# LOCAL TRAFFIC COMMITTEE

Minutes of Meeting  
Held at Wollondilly Shire Council Chambers  
62-64 Menangle Street, Picton 2571  
2:00pm Wednesday 18 July 2018

6. Intercity Rail Park and Ride Document Extract showing maps and designs

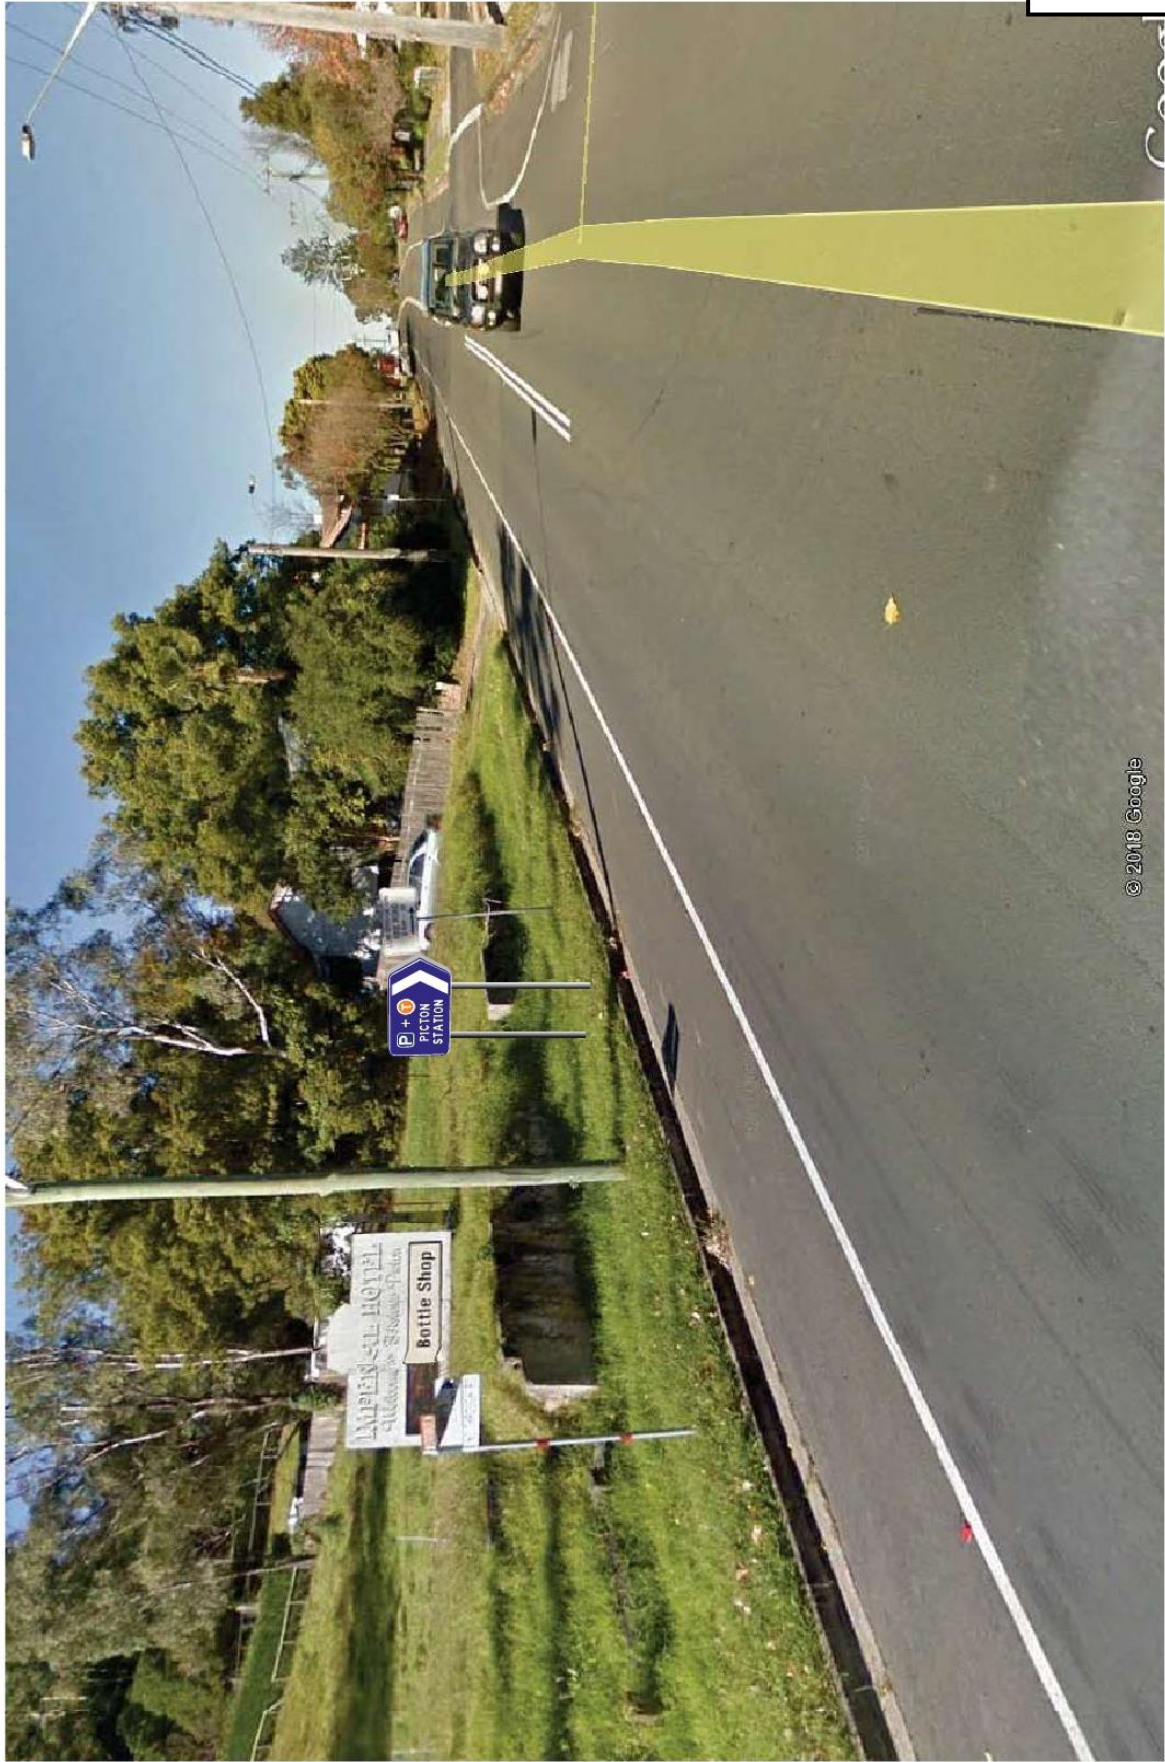
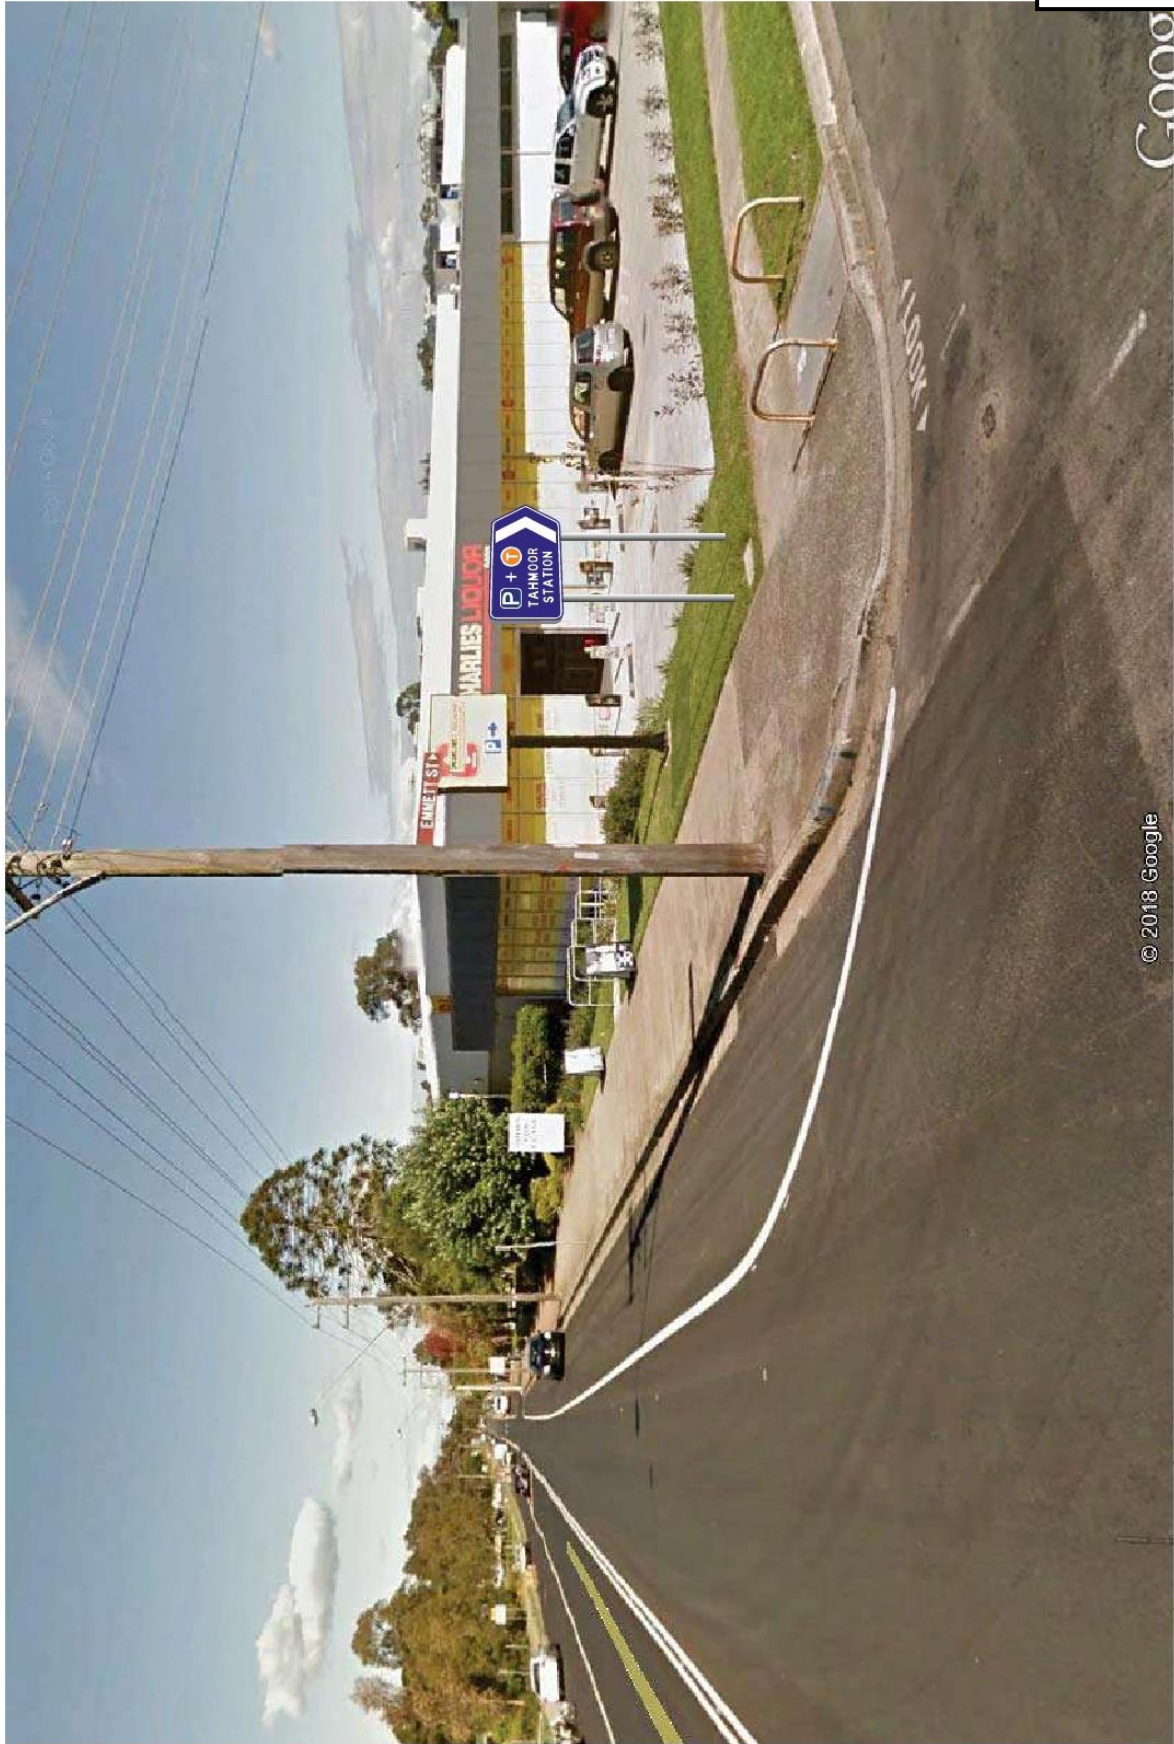
Choong tabled the maps and designs provided by Intercity Rain Park, and put them to the Committee for their information and asking for their comments. The Committee noted the signage and locations. Ian Berthon mentioned with respects to the Tahmoor signage that there is more parking on the opposite side of the station to what is pictured also. Norma asked if we would have to do the installation. Choong responded that we would not. Mick Tanner highlighted that on the Menangle Road image that there is also a weight limit sign next to it. Norma stated that Council would respond to Intercity stating that we approved subject to the view not impeding any current signage.
